# **MCKINNEY 380 C&D LANDFILL**

## **PERMIT MODIFICATION APPLICATION – WITH NOTICE NOD 1 RESPONSE**

TCEQ MSW Permit No. 2278A  
Collin County, Texas

Re: McKinney 380 C&D Landfill, Collin County  
MSW Permit No. 2278A  
Municipal Solid Waste (MSW) Permit Modification – With Notice  
Tracking Nos. 30180759, 30033754; RN110878030 | CN606244051

FIG.III-11.1

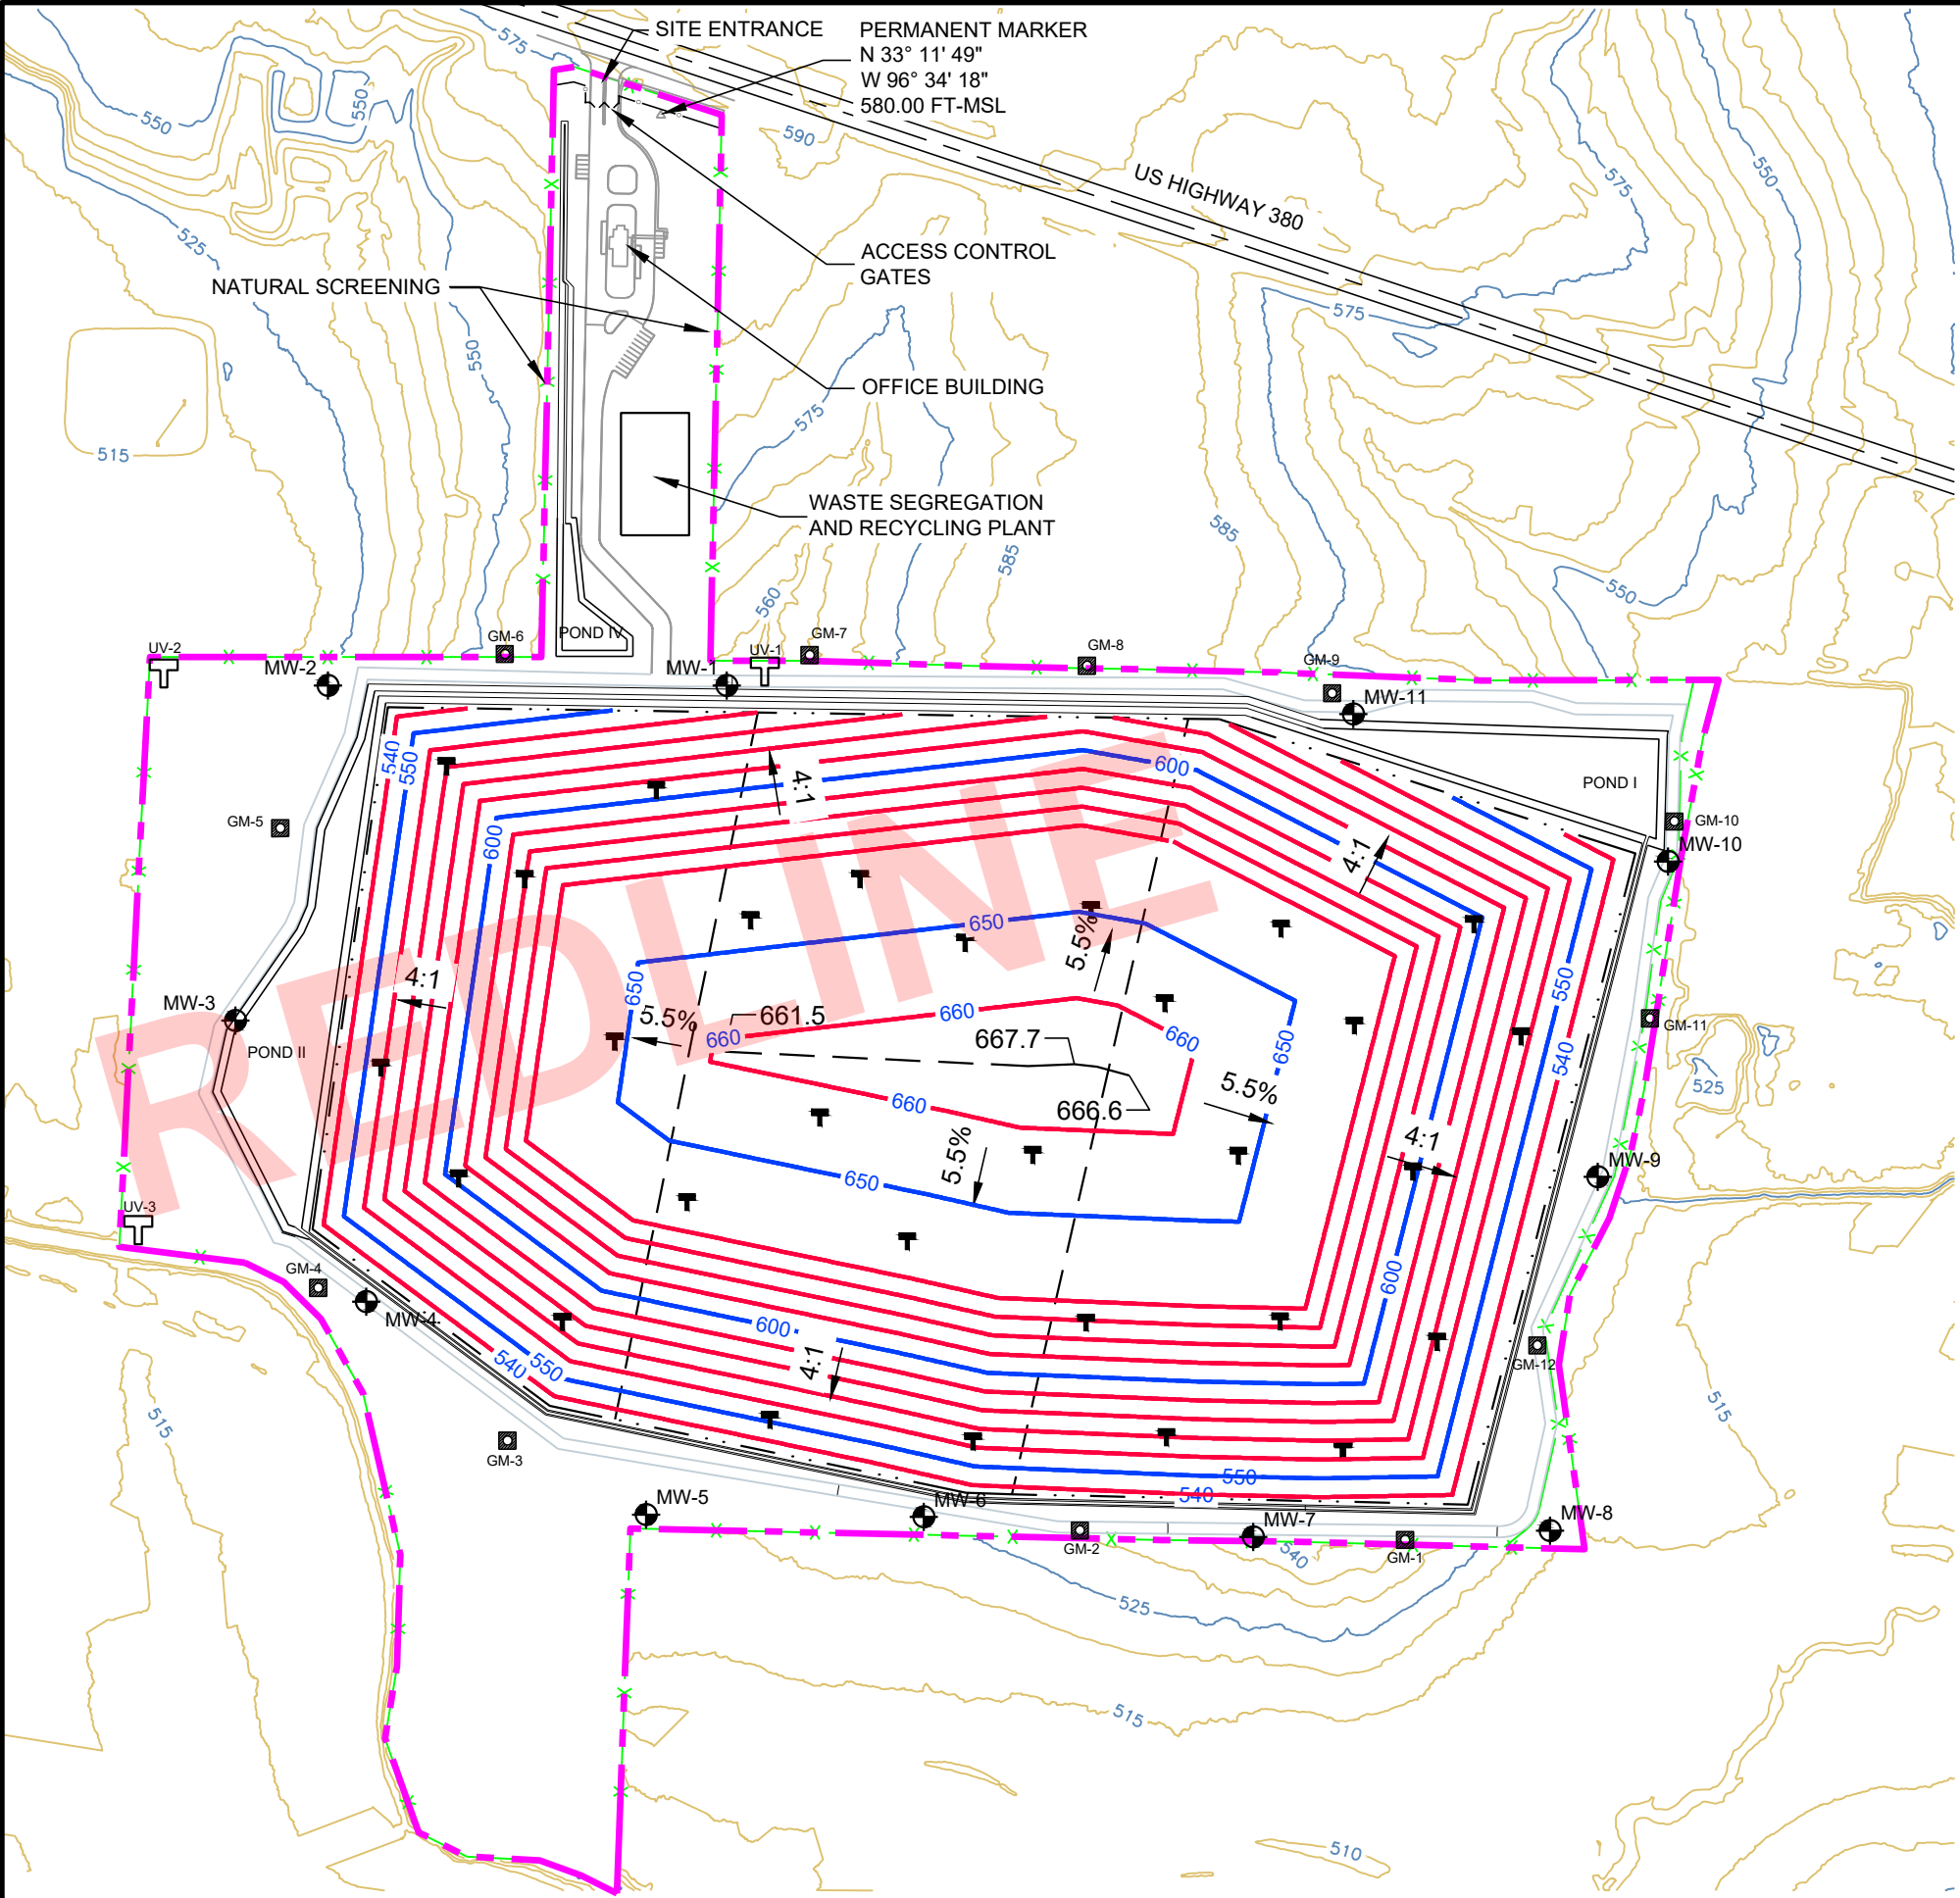
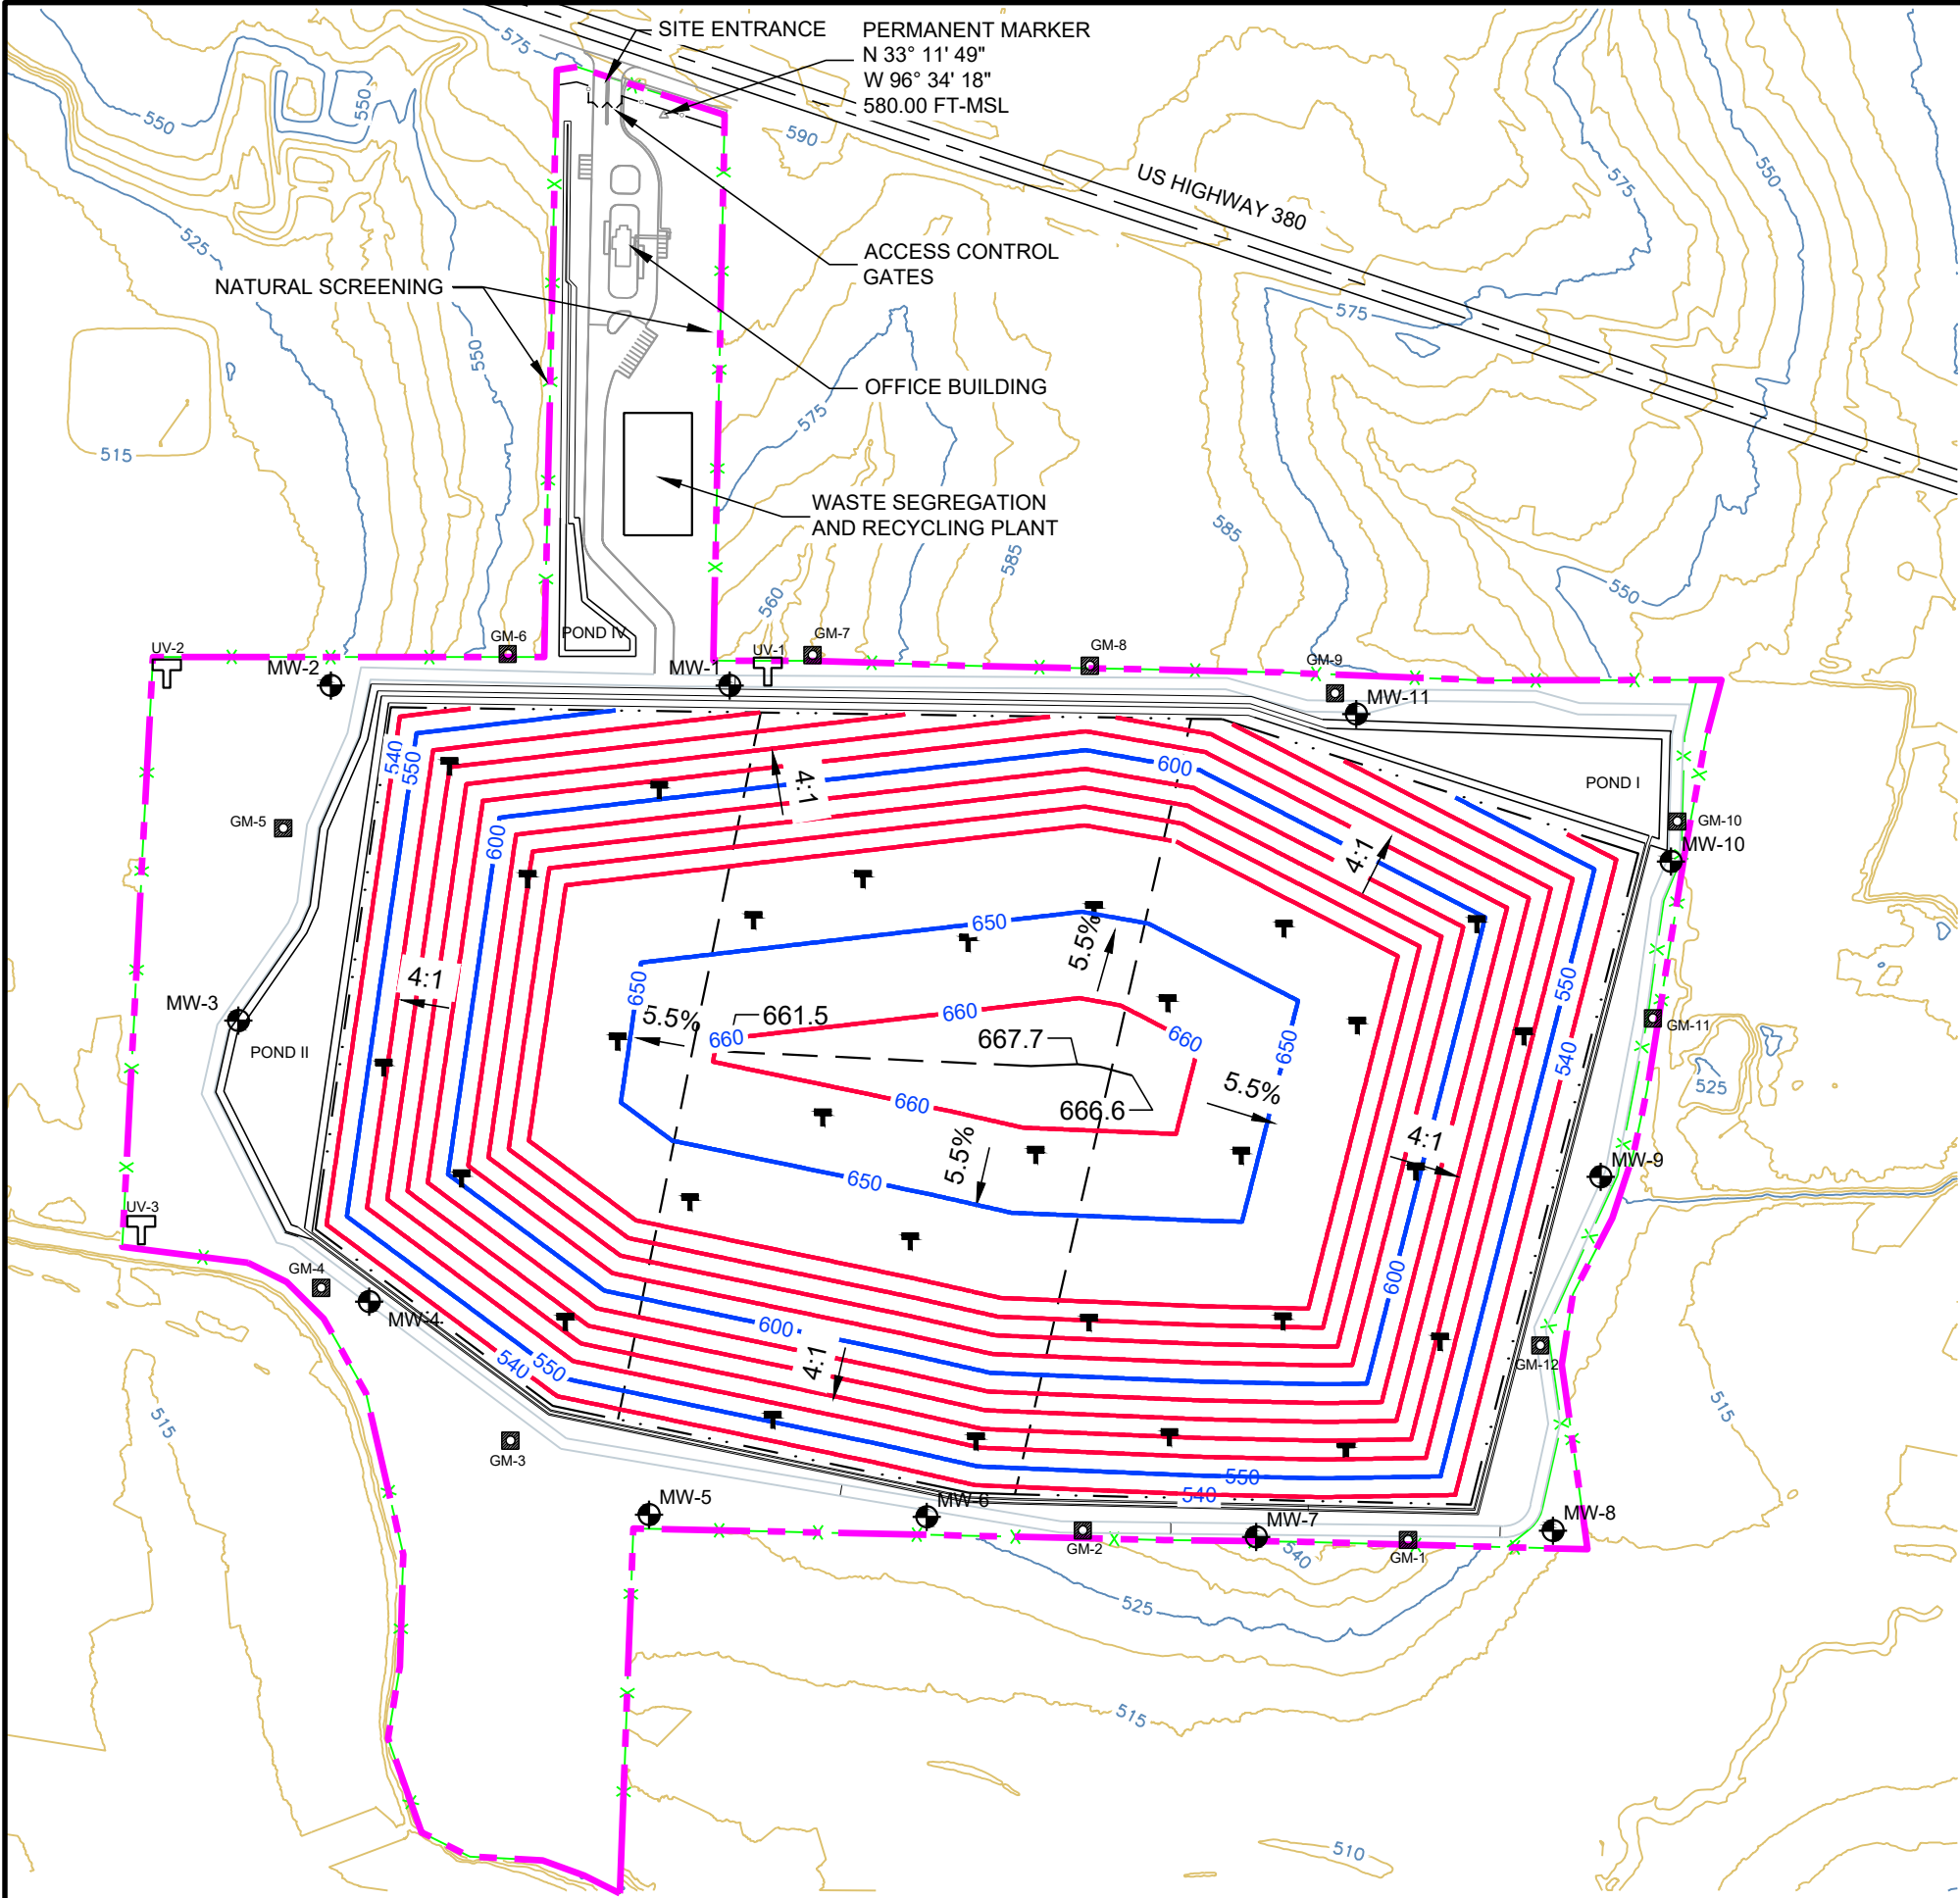
**Comment 7:** The revised Site Layout Plan (Figure III-4.5) indicates "All utility easements, including the sewer easement, are shown on Figure II-3.7 – Site Easements Map." The sanitary sewer easement indicated on the June 21, 2022 version of Figure II-3.7 appears to extend for at least 2,000 feet. Please explain how the proposed number, location, and spacing of the utility vents indicated on Figure III-4.5 dated October 1, 2024 will provide sufficient ventilation for the trench.

In addition to the revisions noted in the responses above, the following revisions have also been completed.

- Revised Figure III-11.1 to remove references to excavation contours and depth from notes. Excavation contours are not shown on this figure.

- Revised Figure III-11.1 to add note 5 stating that vent locations are approximate and maybe adjusted as necessary.

**Response:** *30 TAC §330.371(b)(1)(E) requires landfill units to implement a routine methane monitoring program to ensure that the concentration of methane gas does not exceed 5% by volume in monitoring points, probes, subsurface soils, or other matrices at the facility boundary as defined in the permit. Additionally, 30 TAC §330.371(f) mandates venting of any underground utility trenches that cross the landfill facility boundary.*

*While there is no explicit rule requirement specifying the location, number, or spacing of vents for underground utility trenches, it is standard industry practice to install vents at the points where underground utility trenches cross the landfill facility boundary. This approach facilitates venting within the landfill boundary and ensures compliance with 30 TAC §330.371(b)(1)(E). The proposed number and locations of vents in Figure III-4.5, are based on this standard practice and are designed to monitor and mitigate potential methane accumulation.*

*To address the concern about sufficient ventilation for the trench, if methane concentrations exceeding the regulatory limit are detected at the proposed utility vent locations, the owner/ operator shall follow §330.371(c) to ensure human health and notify the Texas Commission on Environmental Quality (TCEQ), as required. A permit modification application will also be submitted to include additional vents or other measures as necessary to ensure compliance with 30 TAC §330.371.*

- NOTES / REFERENCE**
1. SITE LAYOUT AND RECREATED BY PARKHILL BASED ON MAY 13, 2003 DRAWINGS.
  2. THE INTERNAL ROADS WILL BE CONSTRUCTED AT THE OPERATOR'S DISCRETION TO BEST FIT THE OPERATIONS.
  3. THE LANDFILL WILL BE DEVELOPED SEQUENTIALLY BASED ON THE PHASE NUMBERS SHOWN. APPENDIX II-4.A DISCUSSES LANDFILL CONSTRUCTION SEQUENCE AND DEVELOPMENT IN DETAIL.
  4. MAXIMUM FINAL COVER ELEVATION 667.7 FT-MSL.
  5. VENT LOCATIONS SHOWN ARE APPROXIMATE AND MAY BE ADJUSTED AS NECESSARY
